Docket Number:	09-AFC-07C
Project Title:	Palen Solar Power Project - Compliance
TN #:	200980
Document Title:	Energy Commission Staff's Rebuttal Testimony with Attachments
Description:	N/A
Filer:	Tiffani Winter
Organization:	California Energy Commission
Submitter Role:	Commission Staff
Submission Date:	10/21/2013 4:45:00 PM
Docketed Date:	10/21/2013

PALEN SOLAR ELECTRIC GENERATING
SYSTEM

Docket No. 09-AFC-07C

ENERGY COMMISSION STAFF'S REBUTTAL TESTIMONY

Palen Solar Electric Generating System - Developable and Non-development Areas for the Proposed Riverside East SEZ as Revised

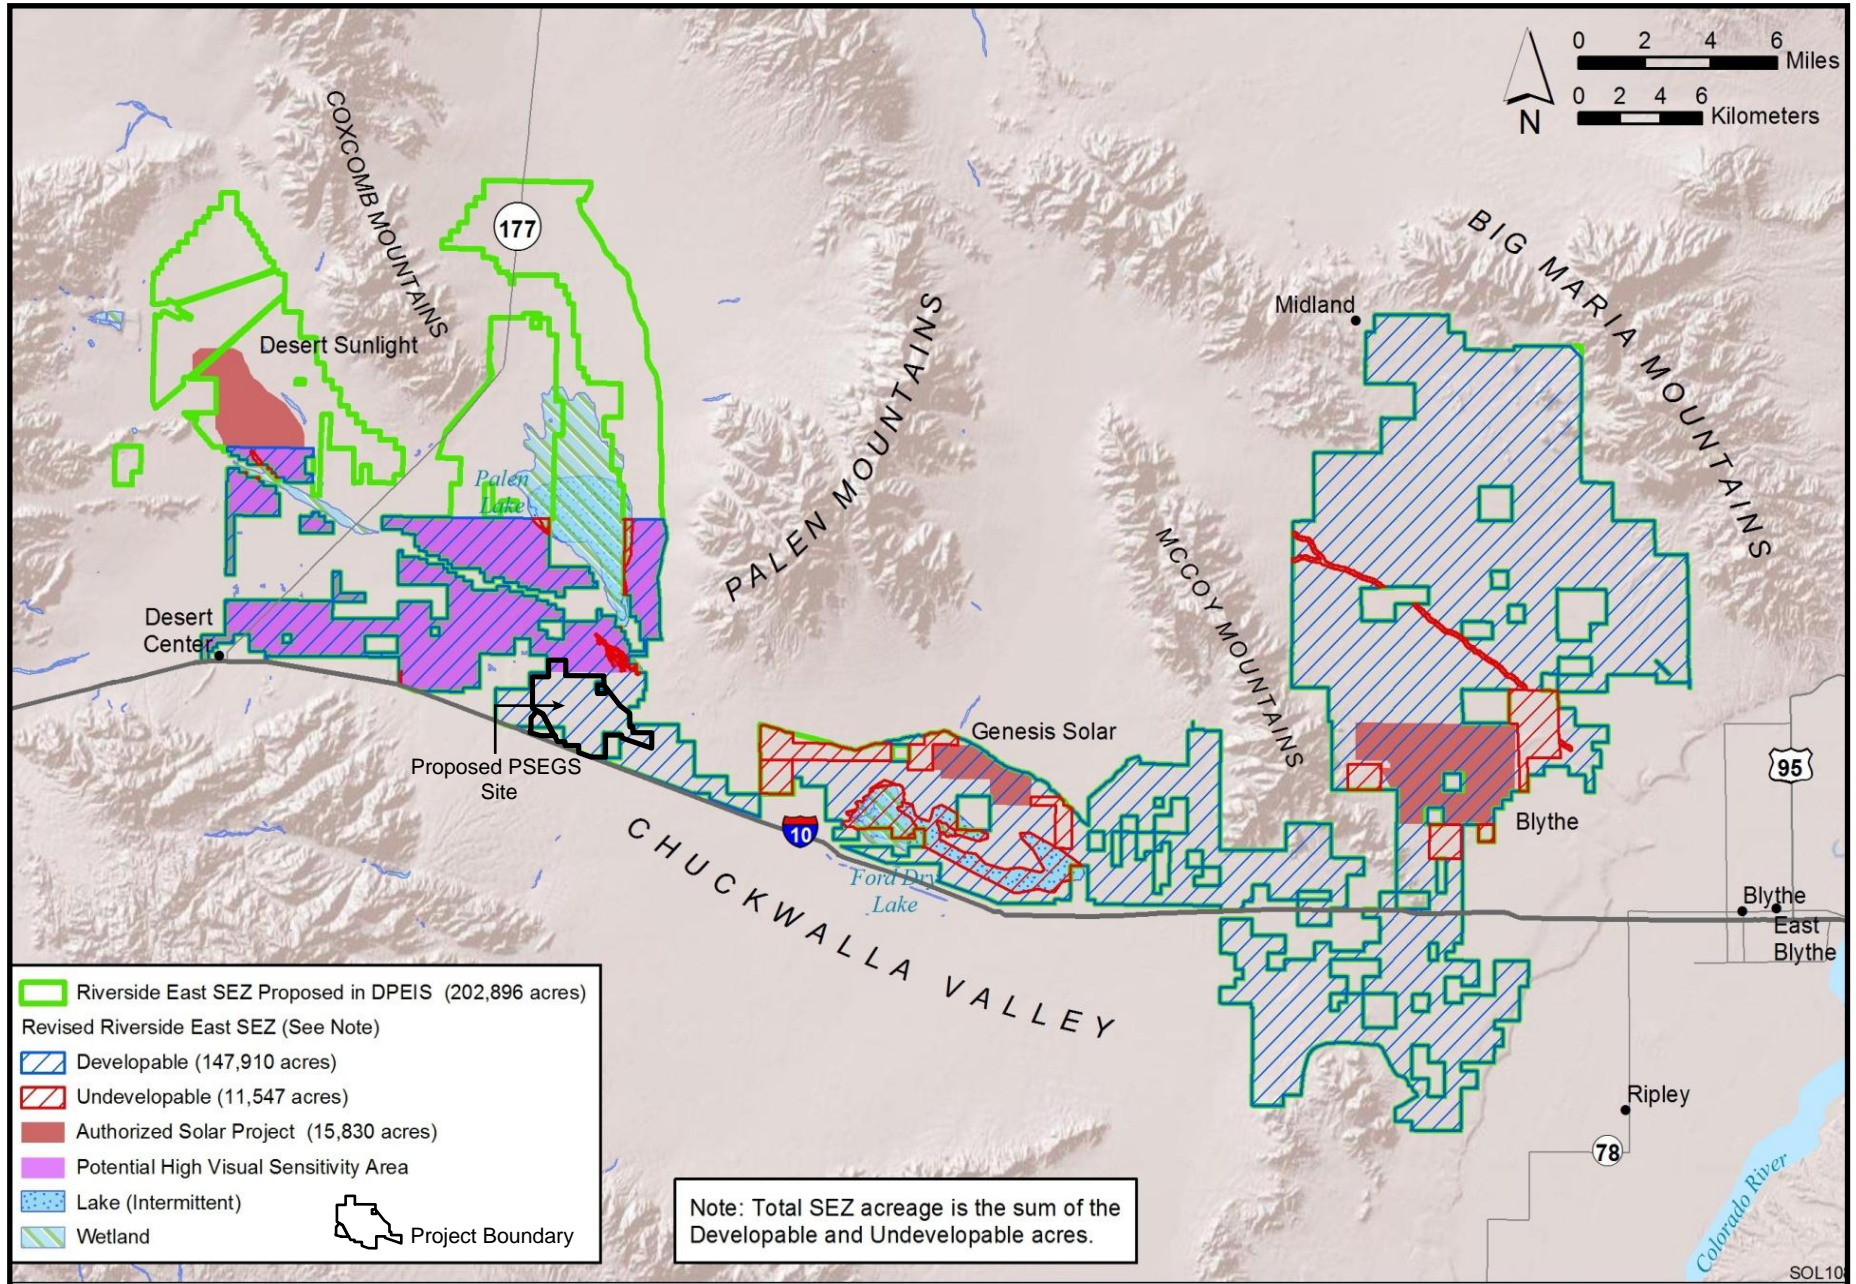
Staff's analysis on page 6.1-16 of the final staff assessment (FSA) describes the location of the PSEGS site in an area designated as "developable" in the Riverside East Solar Energy Zone (SEZ), which is shown in the *Final Programmatic Environmental Impact Statement for Solar Energy Development in Six Southwestern States* (U.S.

Bureau of Land Management and U.S. Department of Energy 2012 [complete reference provided in the FSA]). Alternatives Figure 6 shows the relationship between the proposed PSEGS and the Riverside East SEZ. **(See Alternatives – Figure 6 attached hereto.)**

CBD Proposed Alternative - Adding Private Land Palen Solar Electric Generating System - Mojave Fringe-toed Lizard Observation & Aeolian Sand Zones Impact Minimization Alternative Benefiting Mojave Fringe-toed Lizard and Rare Plants

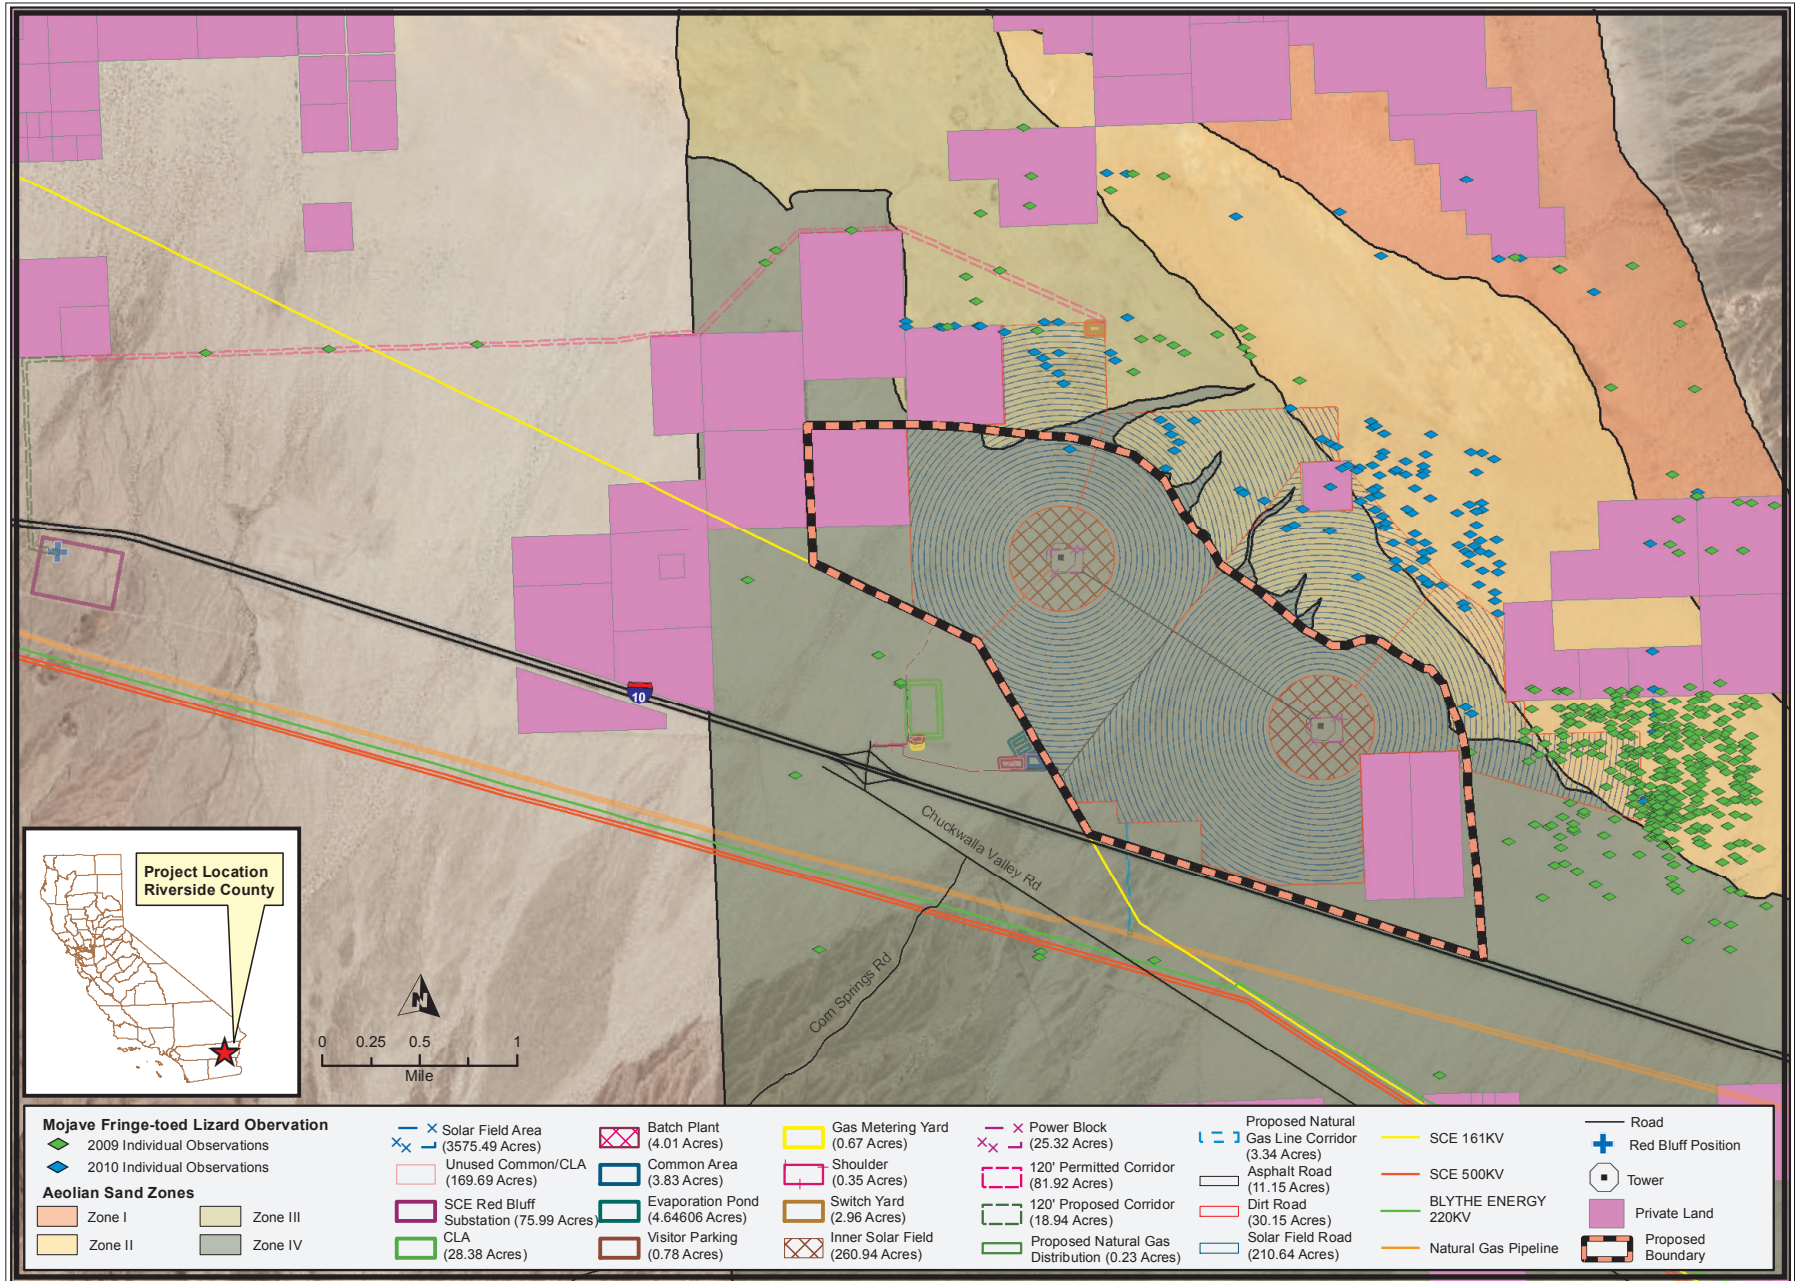
In response to the Center for Biological Diversity's (CBD's) proposed impact minimization alternative (CBD Exhibit 3036), staff submits a figure showing the location of several hundred acres of privately-owned land at the proposed alternative site. The project owner does not have access to the private lands at CBD's proposed impact minimization site. **(See Alternatives - CBD's Proposed Alternative Adding Private Lands attached hereto.)**

CULTURAL RESOURCES- ETHNOGRAPHIC STUDY - FIGURE 6
 Palen Solar Electric Generating System - Pacific to Rio Grande Trails Landscape

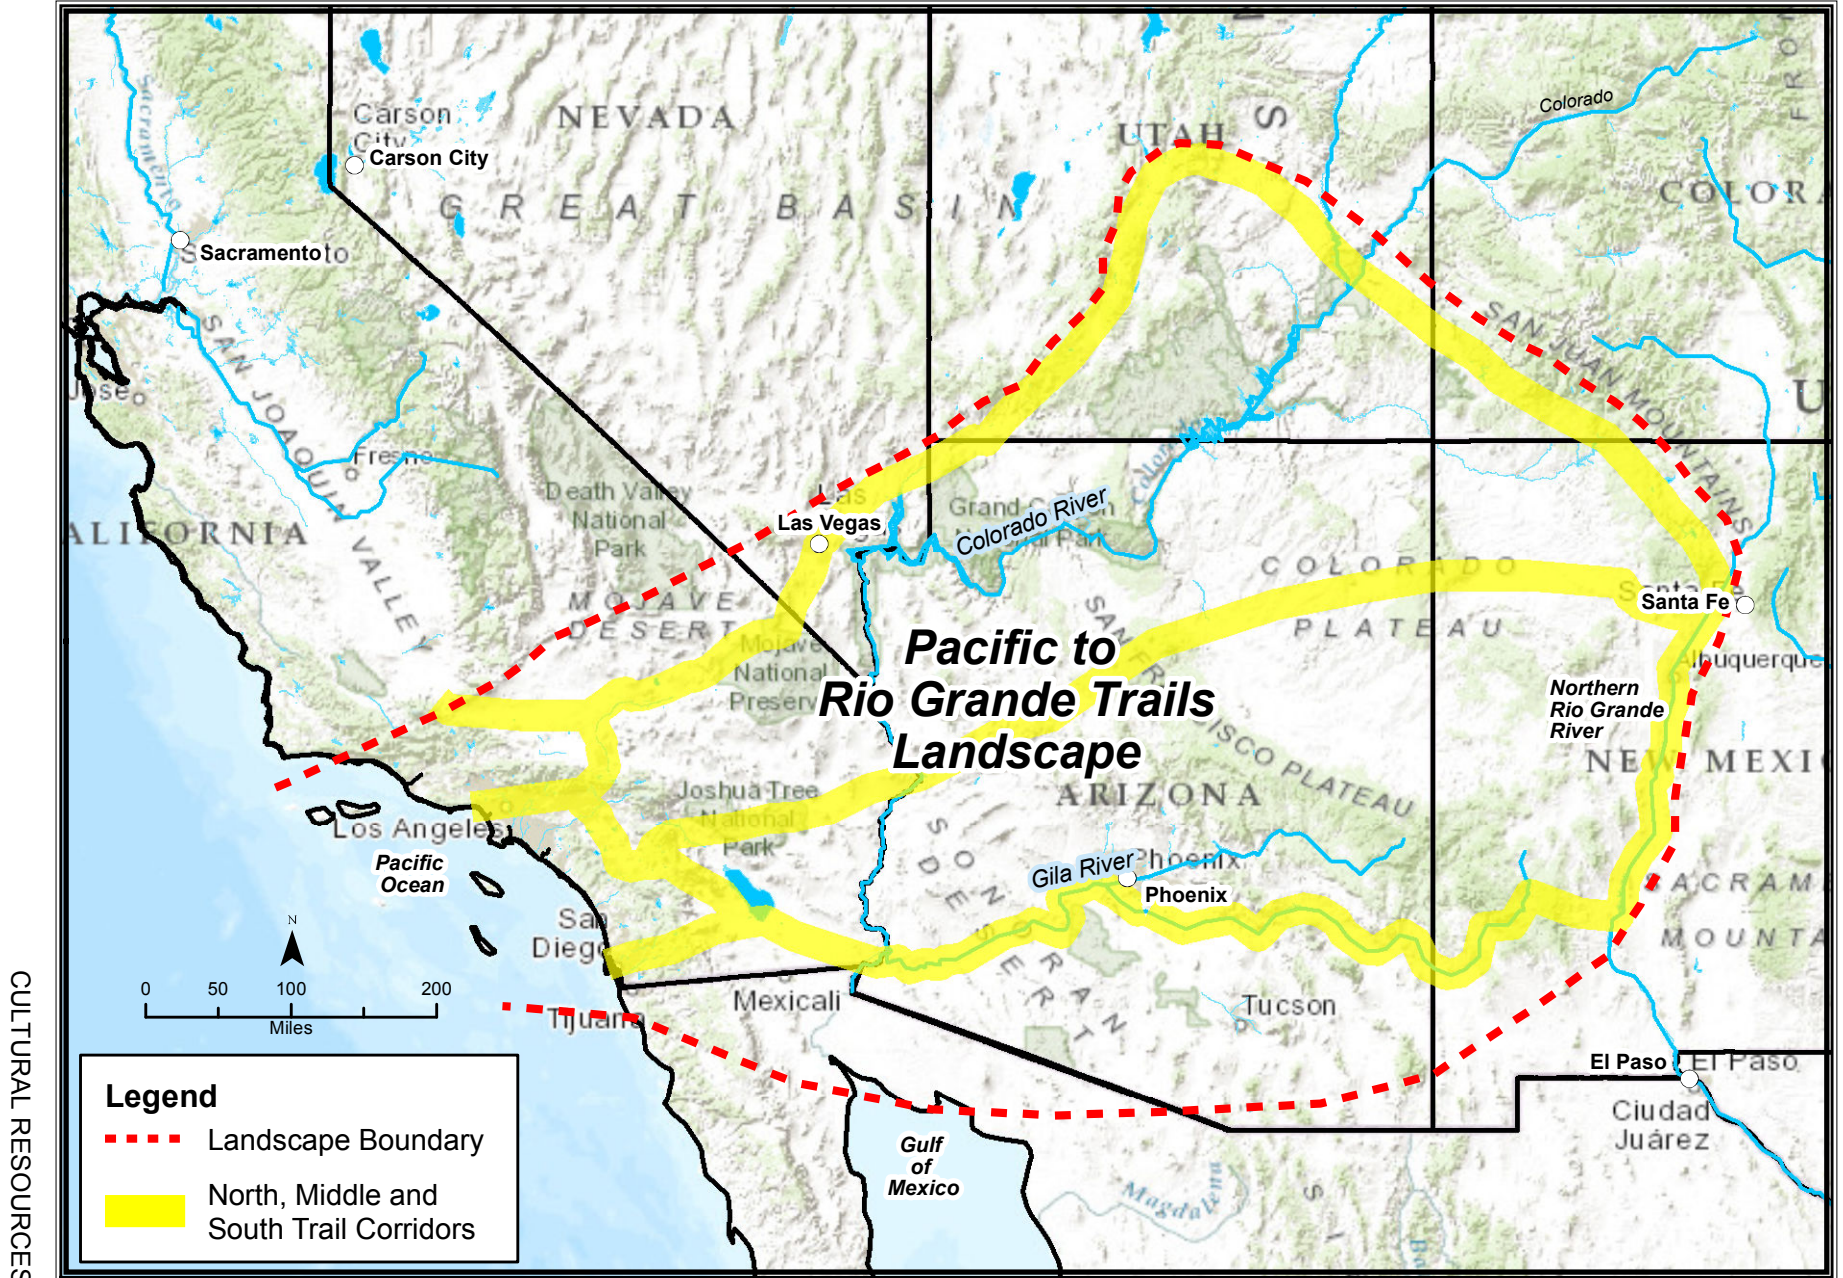
Cultural Resources staff hereby provides a revised Figure 6 – Pacific to Rio Grande Trails Landscape. It has been amended to more accurately reflect the three corridors discerned from a number of source documents. These sources are now also referenced on the amended figure. (**See Cultural Resources-Ethnographic Study – Figure 6 attached hereto.**)
